Planning and Regulatory Committee

Date: **Wednesday 30 July 2025**

7. 251273 - CAR PARK (PLOT 1A & 1B) TOGETHER WITH PLOTS 4 & 5, EAST OF WIDEMARSH STREET, HEREFORD, HEREFORDSHIRE, HR4 9JU Proposed flood alleviation scheme to address historic flooding across the Merton Meadows area of the city.	79 - 204

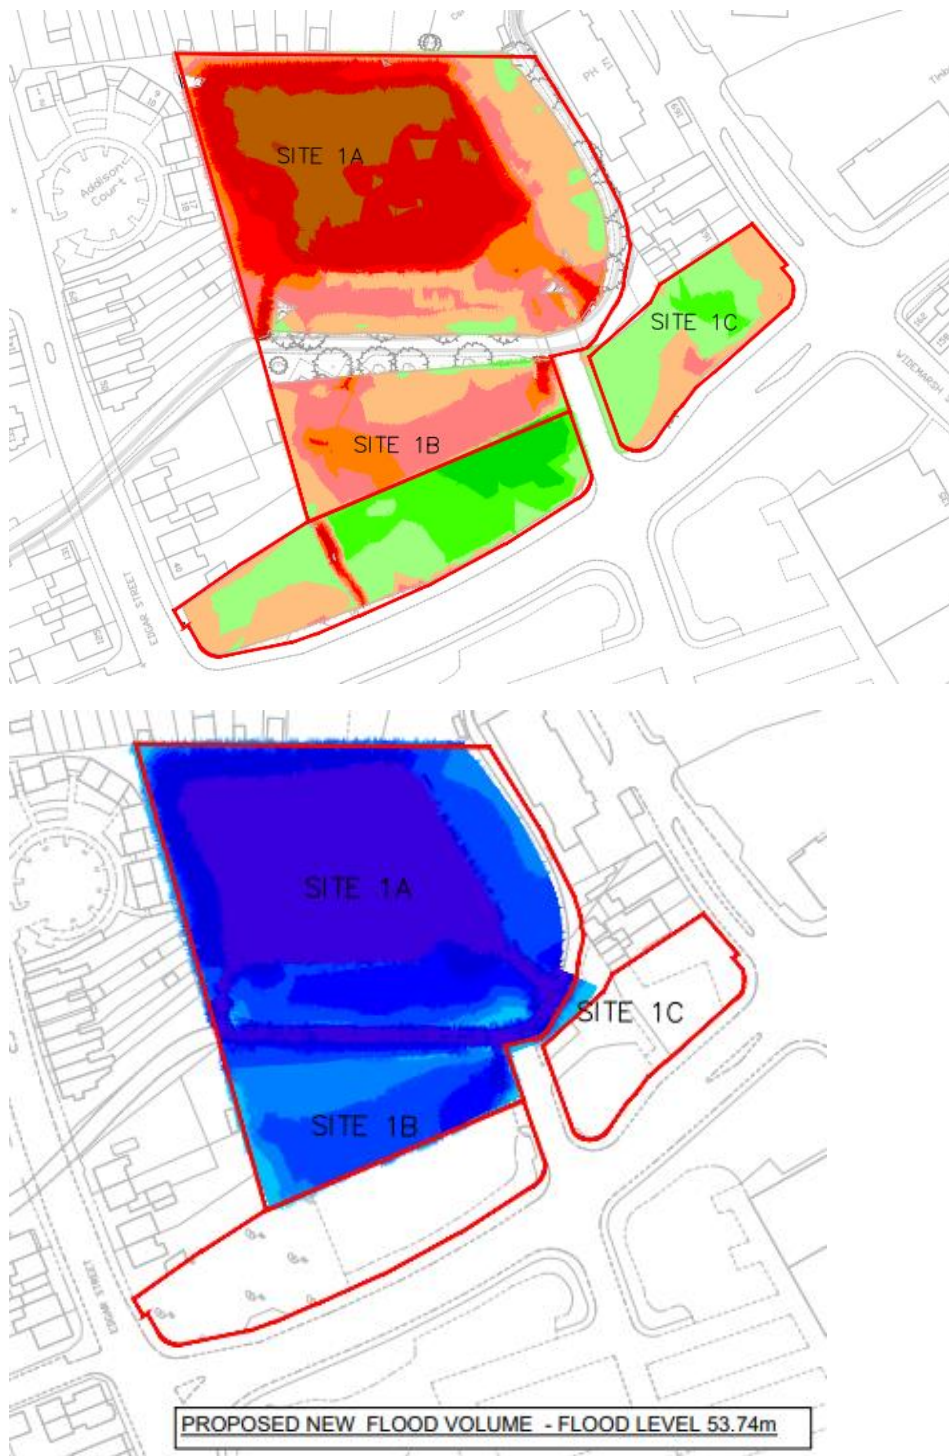
We note that the Cut & Fill drawing for Plots 1A,1B,1C shows works outside of the red line boundary, which are not referenced elsewhere in the planning application. These are the areas that have been highlighted in green (spoil is shown stockpiled).

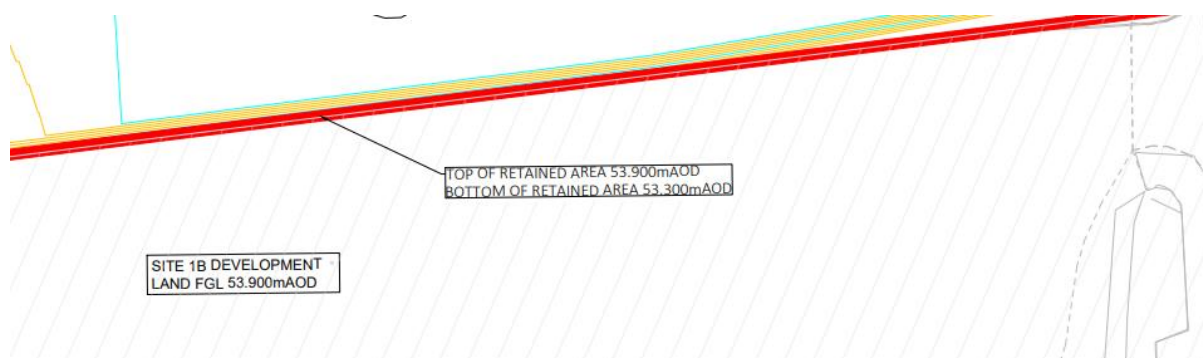
Furthermore the Proposed Contours plan for sites 1A 1B 1C includes proposed Finished Ground Levels for these plots (1B and 1C - 153.90m). The drawing suggests that there will be a retaining feature to hold the fill up.

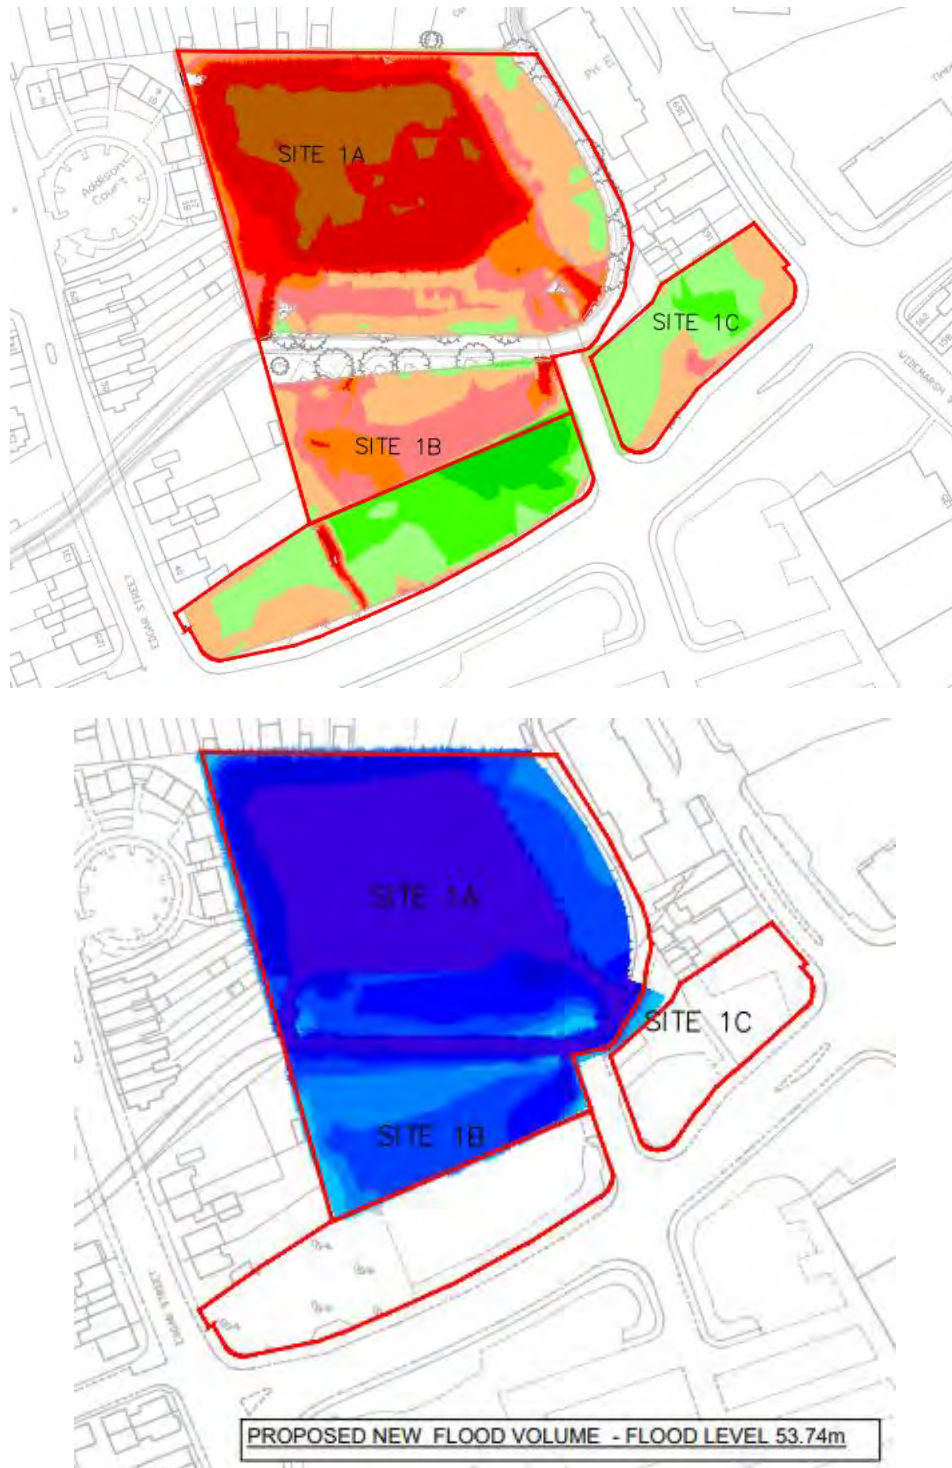
We note that the Cut & Fill drawing for Plots 1A,1B,1C **shows works outside of the red line boundary, which are no referenced elsewhere in the planning application**. These are the areas that have been highlighted in green (spoil is shown stockpiled).

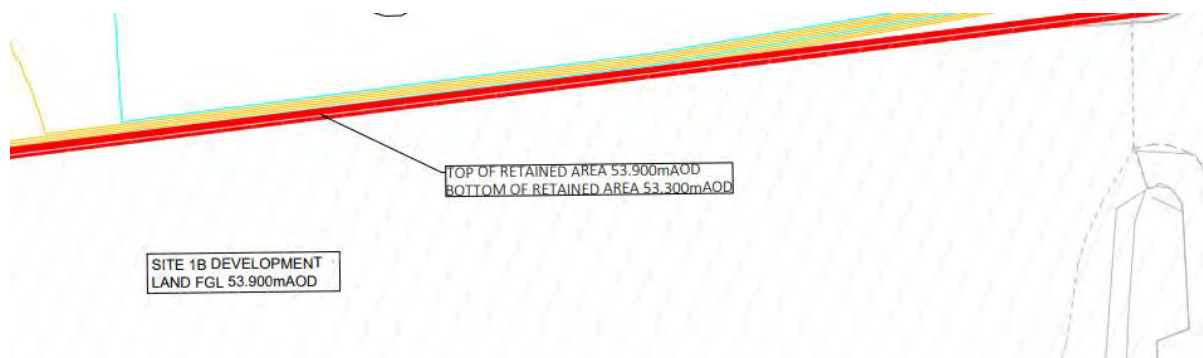
Furthermore the Proposed Contours plan for sites 1A 1B 1C includes proposed Finished Ground Levels for these plots (1B and 1C - 153.90m). The drawing suggests that there will be a retaining feature to hold the fill up.

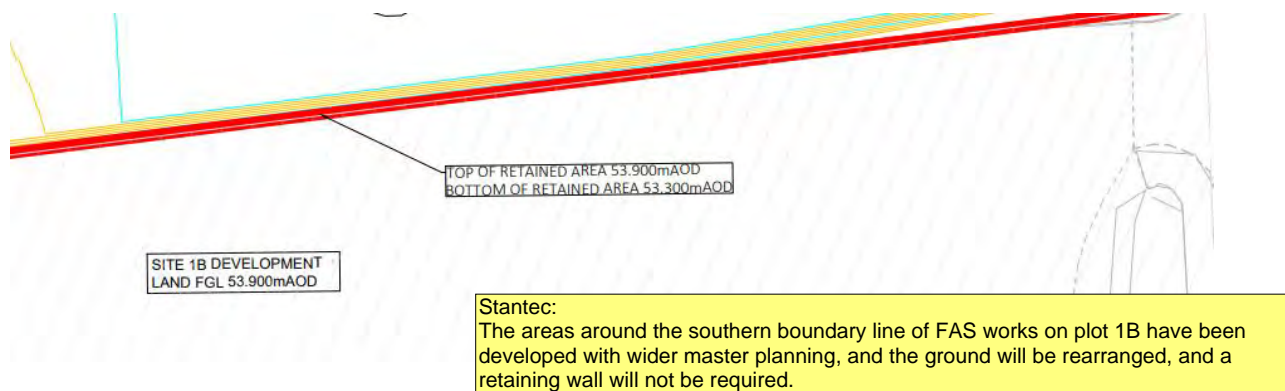
There is conflicting commentary on the Notes on the Flood Compensation drawing 1A 1B 1C

The plot 1B and 1C are part of future wider masterplan and the consultation will take place with EA to ensure that the proposal is accepted.

The proposed FGL finished ground levels of 53.90 are set 150mm above 1:100years+CC event and the FFL are set further 150mm above the finished ground level or 300mm above the flood level. These levels are going to be discussed with EA.
